Marin County Flood Control and Water
Conservation District
**Corte Madera Creek Flood Risk Management
Project, Phase 1**
Final Environmental Impact Report
Volume 1: Comments and Responses to Comments
State Clearinghouse No. 2020080353

**Marin County Flood Control and Water
Conservation District
Corte Madera Creek Flood Risk Management
Project, Phase 1
Final Environmental Impact Report
Volume 1: Comments and Responses to Comments
State Clearinghouse No. 2020080353**

Figure 2-9 Alternative 1 Changes in Water Surface Elevation from Future Conditions, 25-Year Flood Event (Upper Corte Madera Creek)

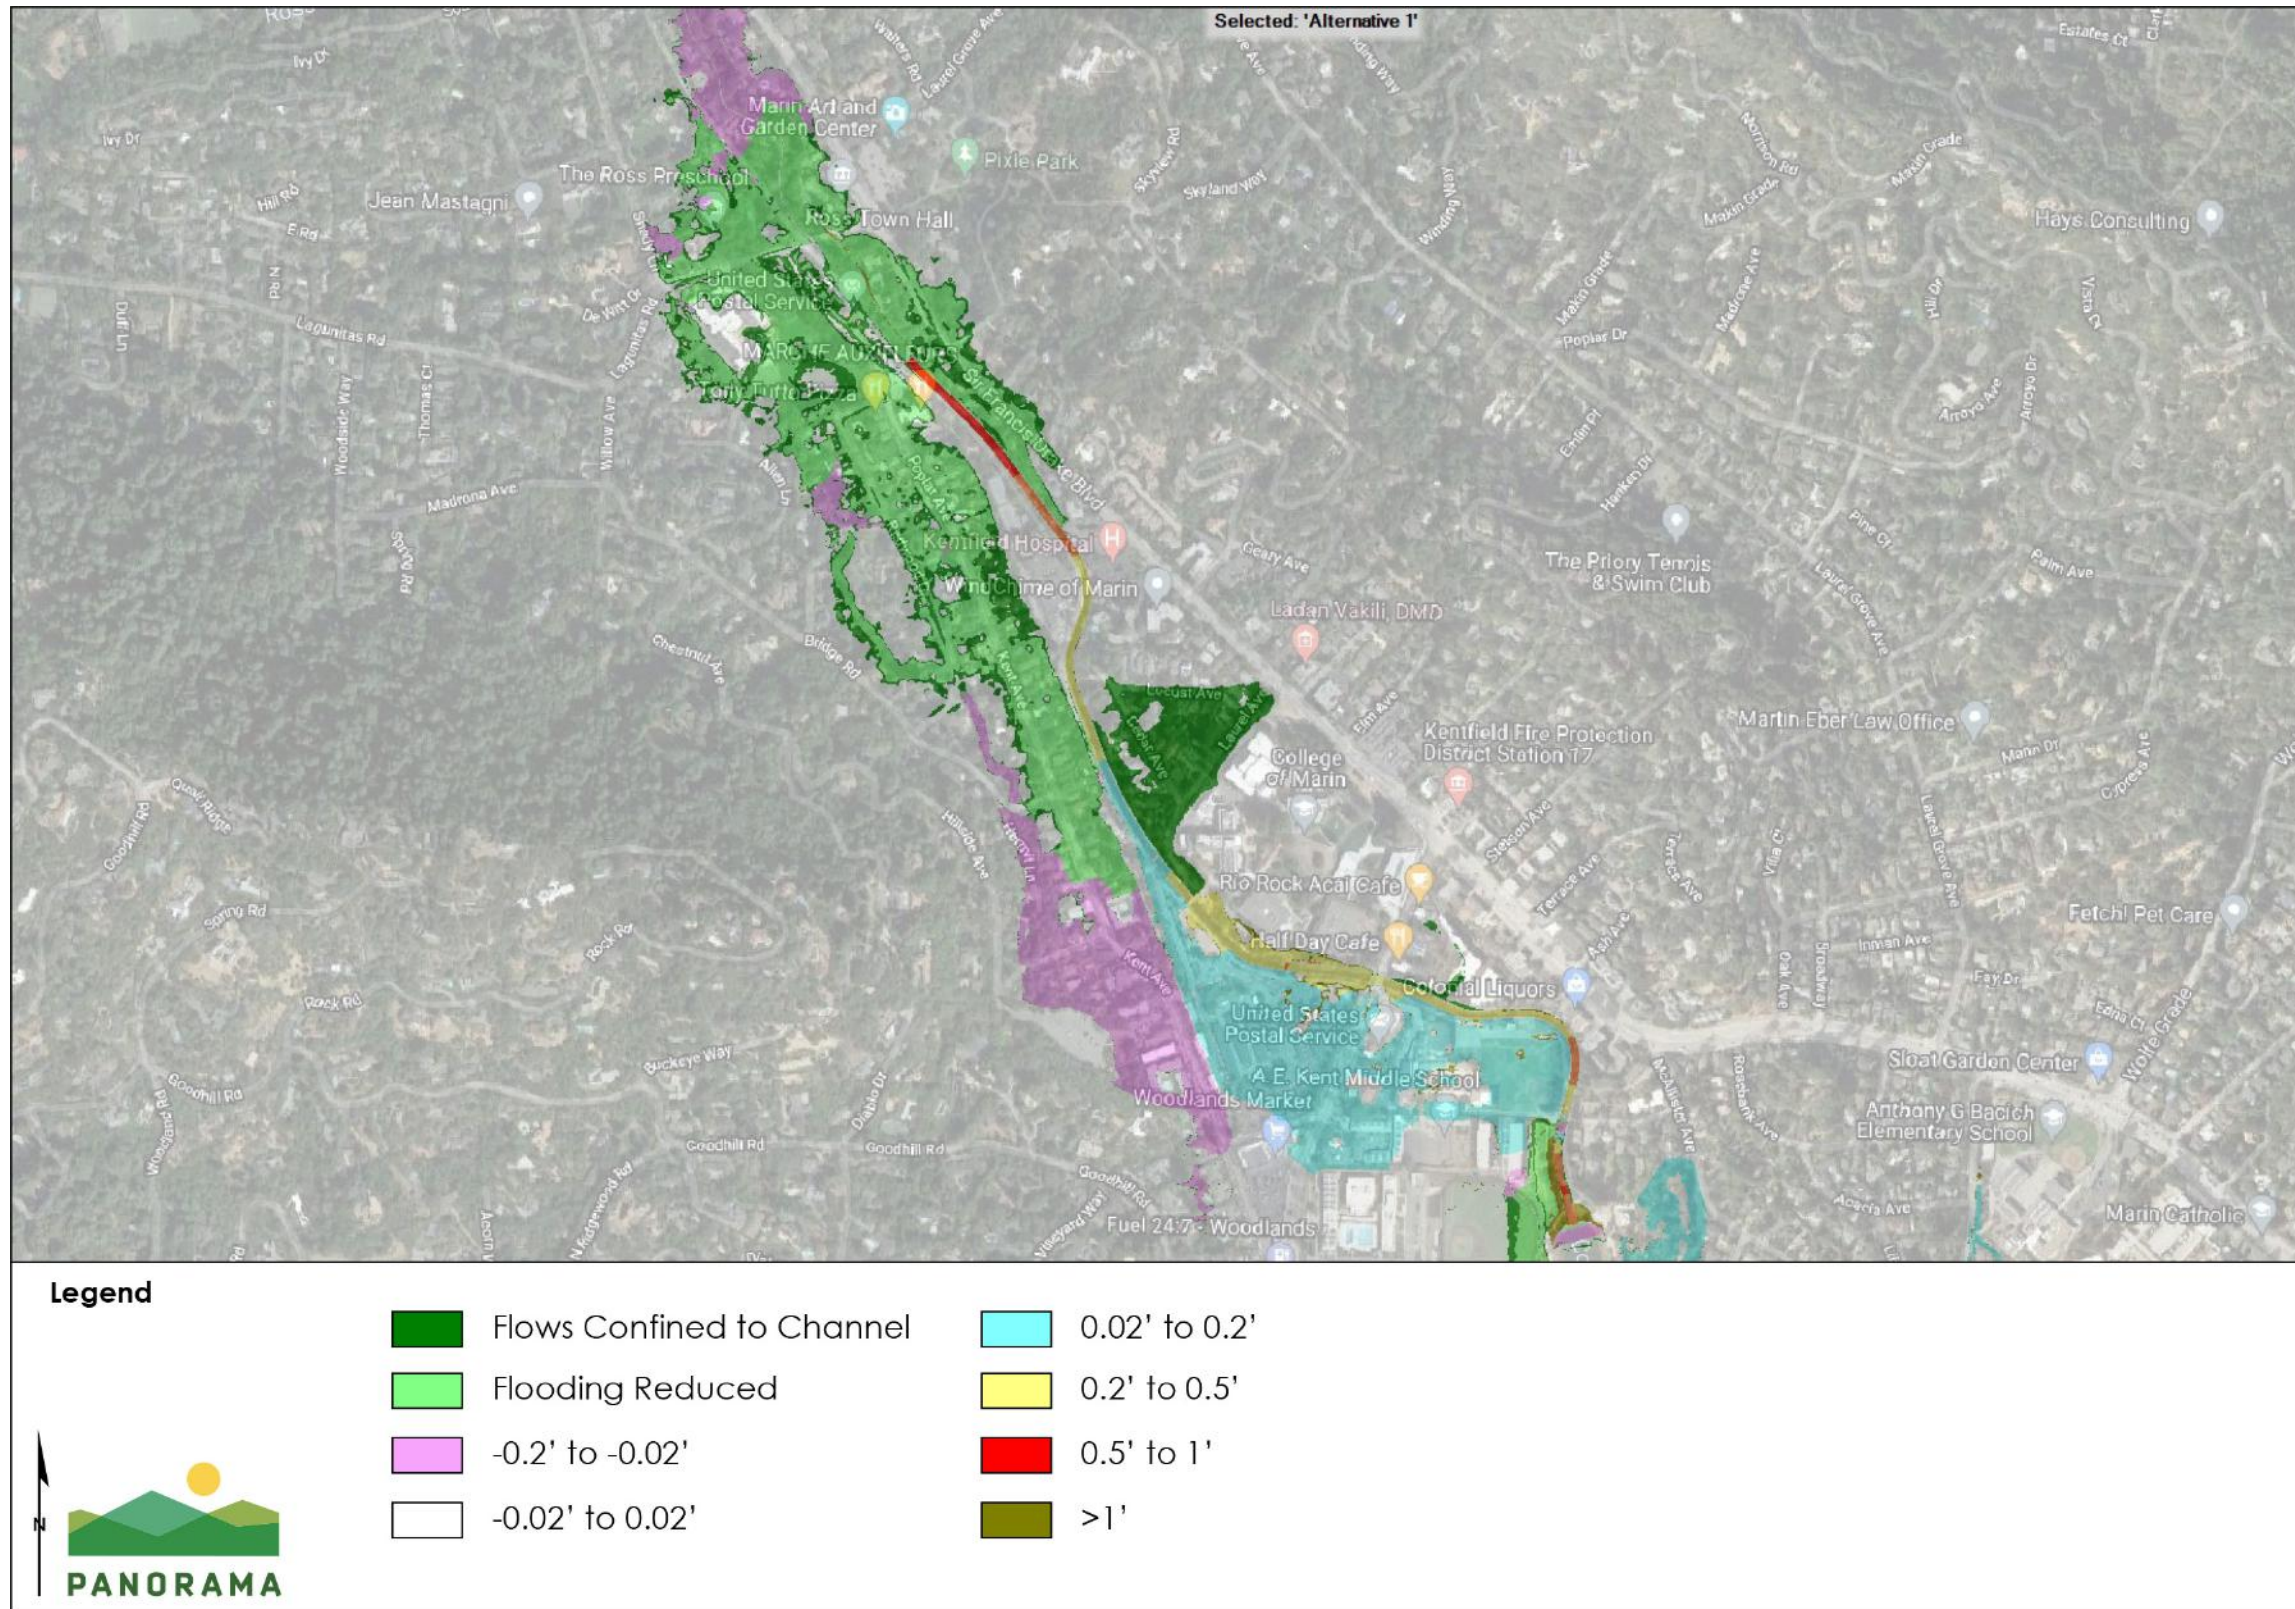
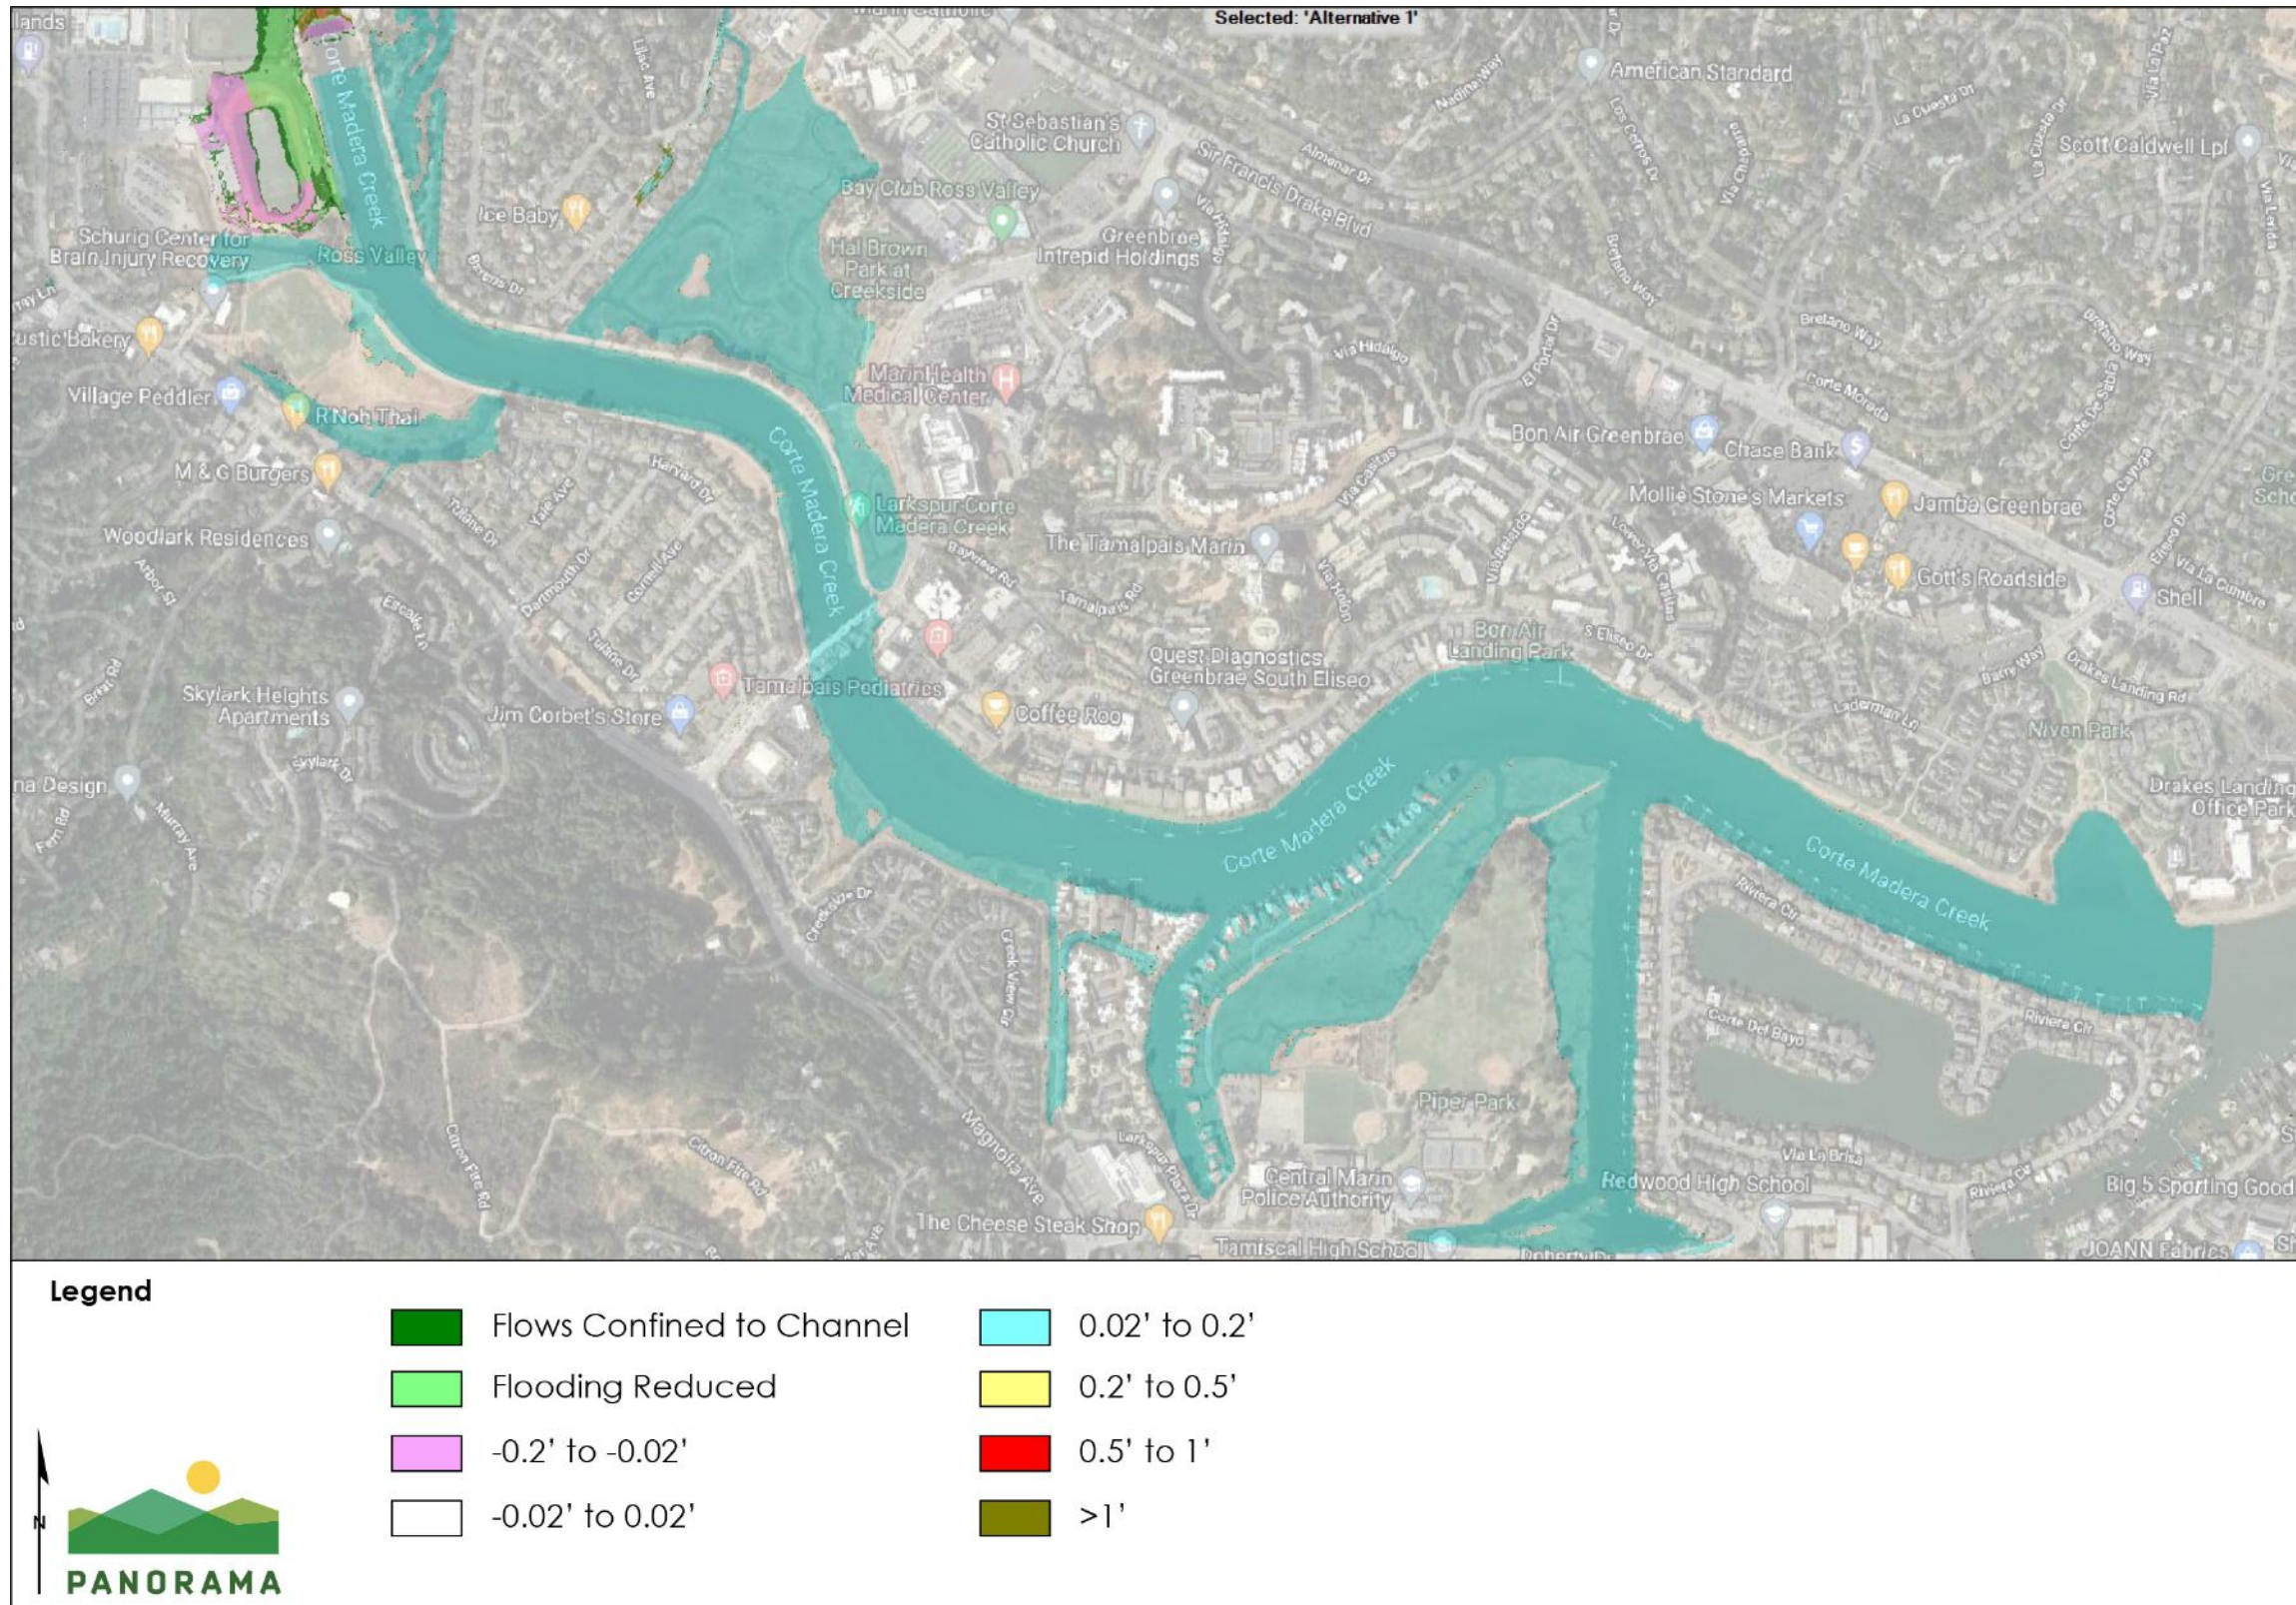
The geographic extent of the figures showing the changes in WSE differs from the figures included in the Draft EIR. The geographic extent of the figures was expanded to show areas downstream from Unit 2 in response to comments from the City of Larkspur. As discussed on page 3.9-39 in the Draft EIR, a threshold of 0.2 foot (2.4 inches) was used for determining whether a potentially significant increase or decrease in WSE would occur at any structure. The 0.2-foot threshold is a reasonable level of precision for evaluating flooding impacts, considering the standards for accuracy and precision associated with hydraulic modeling.

Figure 2-1 through Figure 2-6 show the Alternative 1 changes to the WSE and reflect the difference in WSE between the Existing Condition Without Project and Existing Condition With Alternative 1 scenarios under a 10-, 25-, and 100-year flood, using the updated modeling for the 60 percent design. Figure 2-7 through Figure 2-12 show the Alternative 1 changes to the WSE under for the future condition scenario, and reflect the difference in WSE between the Future Condition Without Project and Future Condition With Alternative 1 under the 10-, 25-, and 100-year flood conditions. The assumptions used in the future condition modeling are described on pages 3.9-35 through 3.9-37 in Section 3.9 in the Draft EIR and are supplemented by the model updates described above. Figure 2-13 through Figure 2-18 show the Alternative 1 changes to the WSE under a “high-emissions likely” sea-level rise scenario, to reflect 2100 projected sea-level rise based on the 2018 Update of the State of California Sea-Level Rise Guidance (California Ocean Protection Council, 2018). Figures 2-13 through 2-18 reflect the difference in WSE between the Year 2100 Future Condition Without Project and Year 2100 Future Condition with Alternative 1 scenarios under the 10-,25-, and 100-year flood conditions.

Areas shown in the figures as “Flows Confined to Channel” are areas that are currently flooded by Corte Madera Creek, which are predicted to no longer have flood inundation from Corte Madera Creek overtopping after Alternative 1 is implemented. Areas shown in the figures with “Flooding Reduced” are areas with reduced flood inundation (greater than 0.2 foot) from creek overtopping after Alternative 1 is implemented. The change in WSE shown on the maps reflects a comparison between WSE without implementation of Alternative 1 and the WSE after implementation of Alternative 1 for each modeled scenario.
